RJST / MATSUSHIMA

## MATSUSHIMA REVERSAL THREE DEPARTURE

## STANDARD DEPARTURE CHART - INSTRUMENT

INSTRUMENT APPROACH CHART

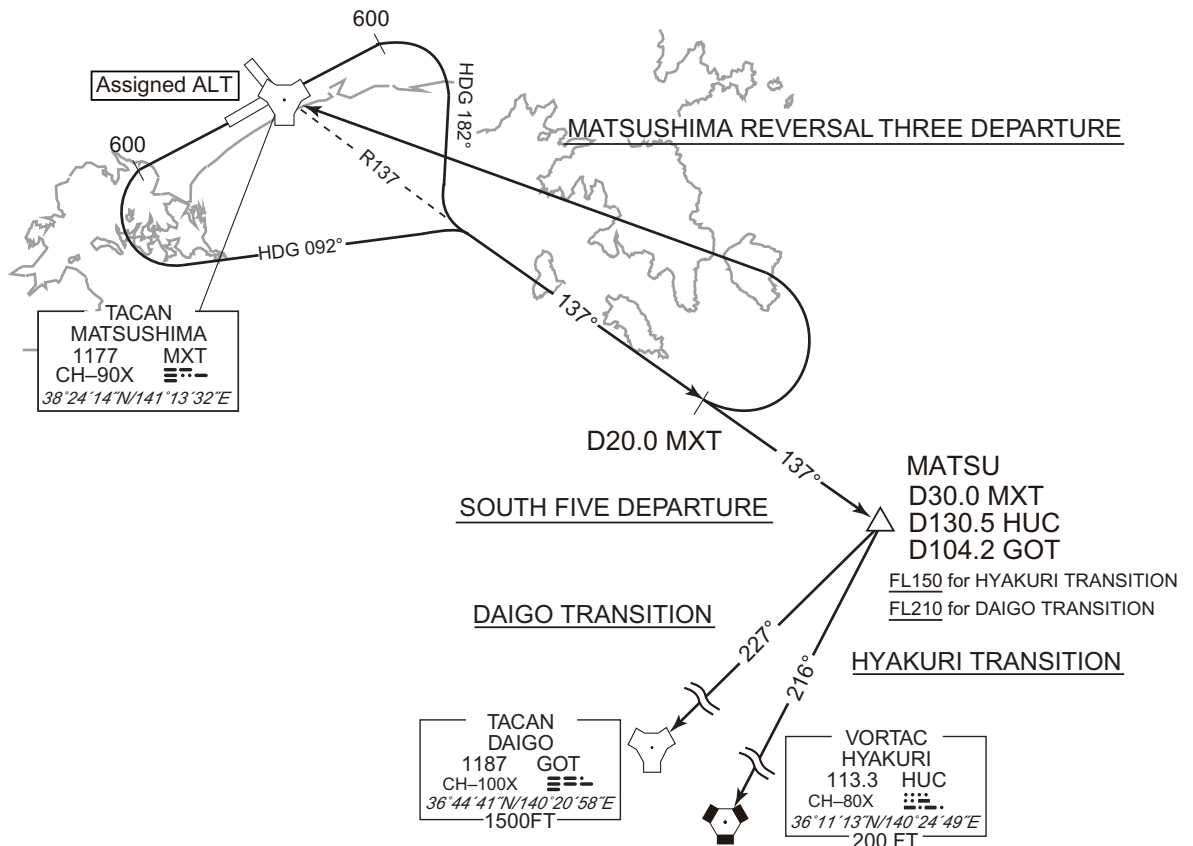
CHANGE :PROC renamed(MATSUSHIMA REVERSAL THREE DEPARTURE, SOUTH FIVE DEPARTURE).PROC course(MATSUSHIMA REVERSAL THREE DEPARTURE, SOUTH FIVE DEPARTURE).  
ALT restriction for RWY07. Note added(HYAKURI TRANSITION). Note(MATSUSHIMA REVERSAL THREE DEPARTURE, SOUTH FIVE DEPARTURE).

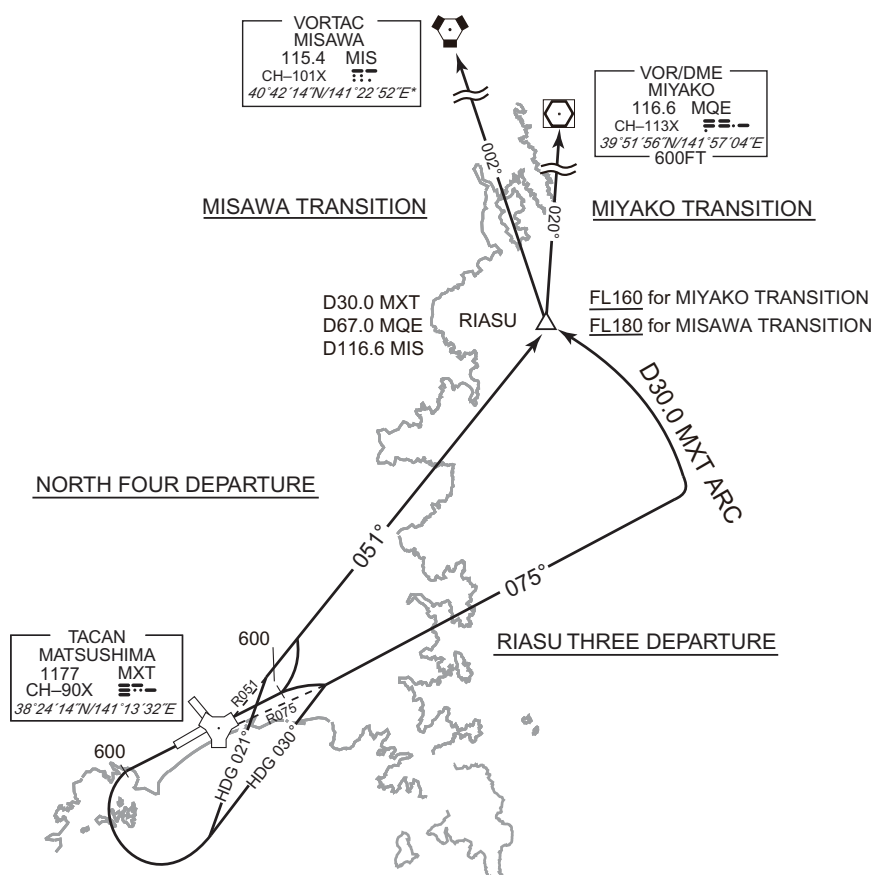
CHANGE : PROC renamed(NORTH FOUR DEPARTURE, RIASU THREE DEPARTURE, PROC course(NORTH FOUR DEPARTURE, RIASU THREE DEPARTURE), EAST REVERSAL TWO DEPARTURE abolished.  
 ALT restriction for RWY07. Note(NORTH FOUR DEPARTURE, RIASU THREE DEPARTURE).

WEST FOUR DEPARTURE

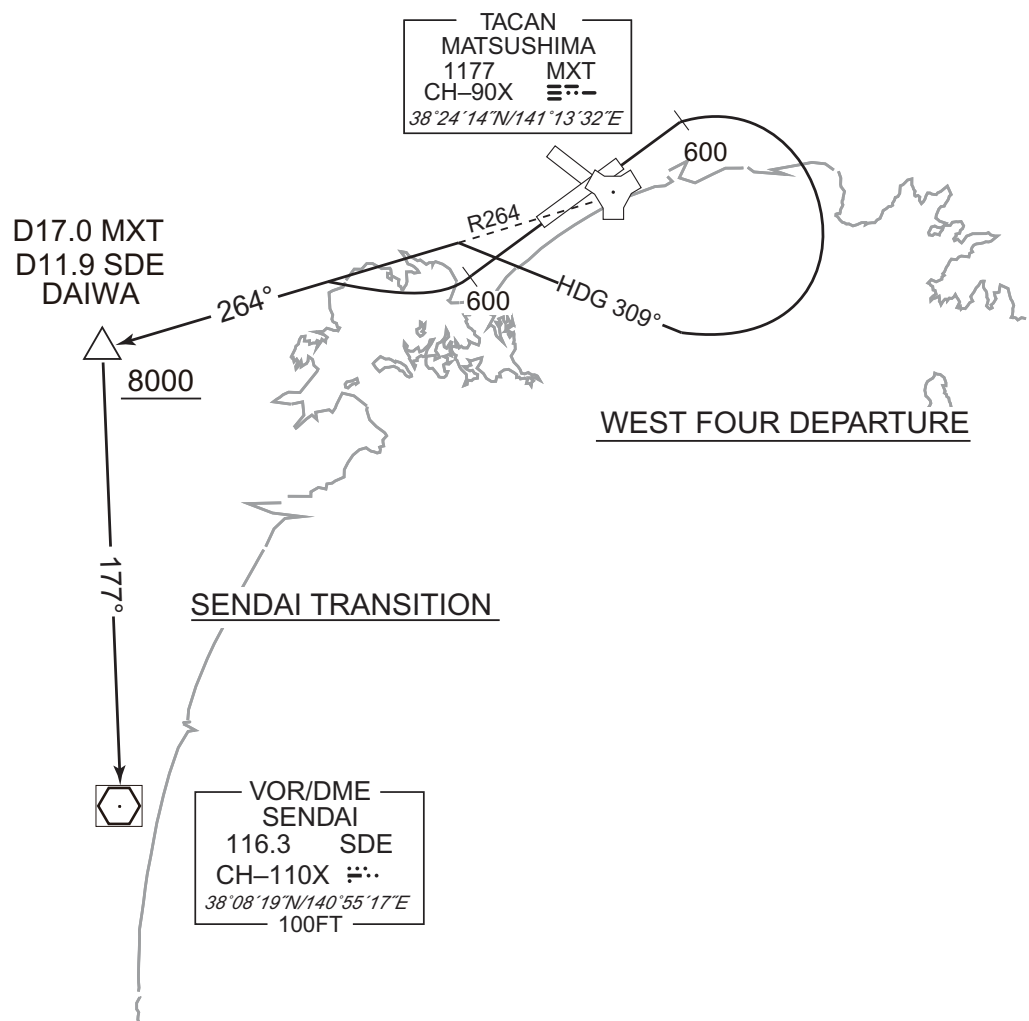
CHANGE : PROC renamed(WEST FOUR DEPARTURE), PROC course(WEST FOUR DEPARTURE), NIIGATA TRANSITION abolished. ALT restriction for RWY07. Note(WEST FOUR DEPARTURE).

TACAN Y RWY25

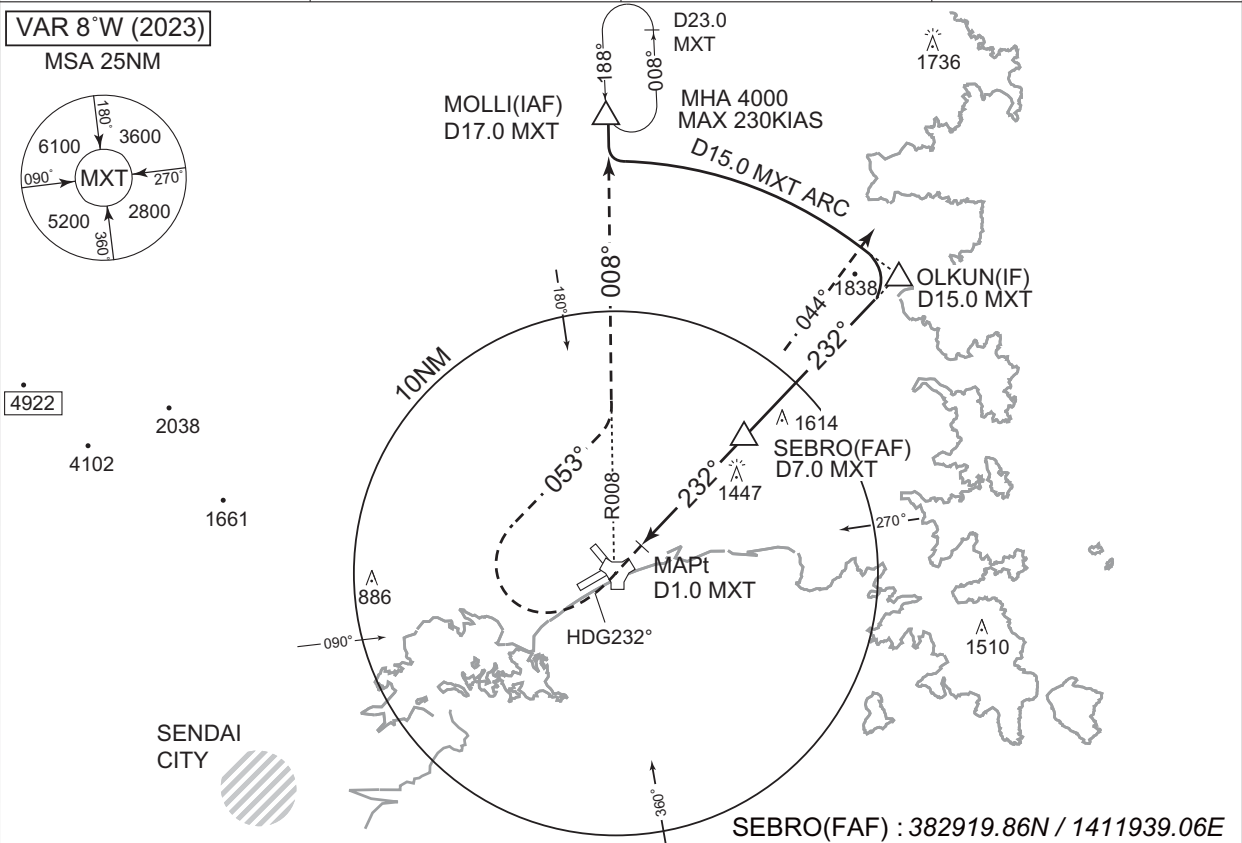
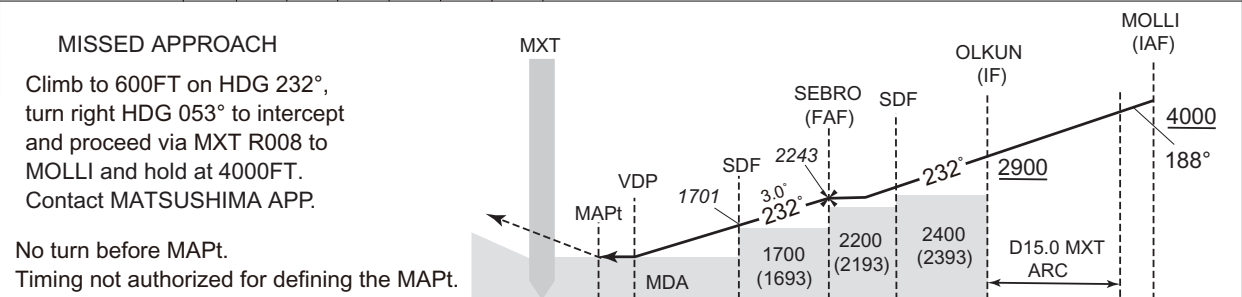
CHANGE: :PROC renamed. PROC course. Missed APCH PROC. MINIMA. PROC ALT established. HLDG pattern. OLKUN, SEBRO established. ALT (3.0°APCH Path) established. THR ELEV. Circling restriction. DME to MXT, NM to THR added. VAR. MSA.

CHANGE : Correction of misdescription(Course FM MOLLI to OLKUN deleted).
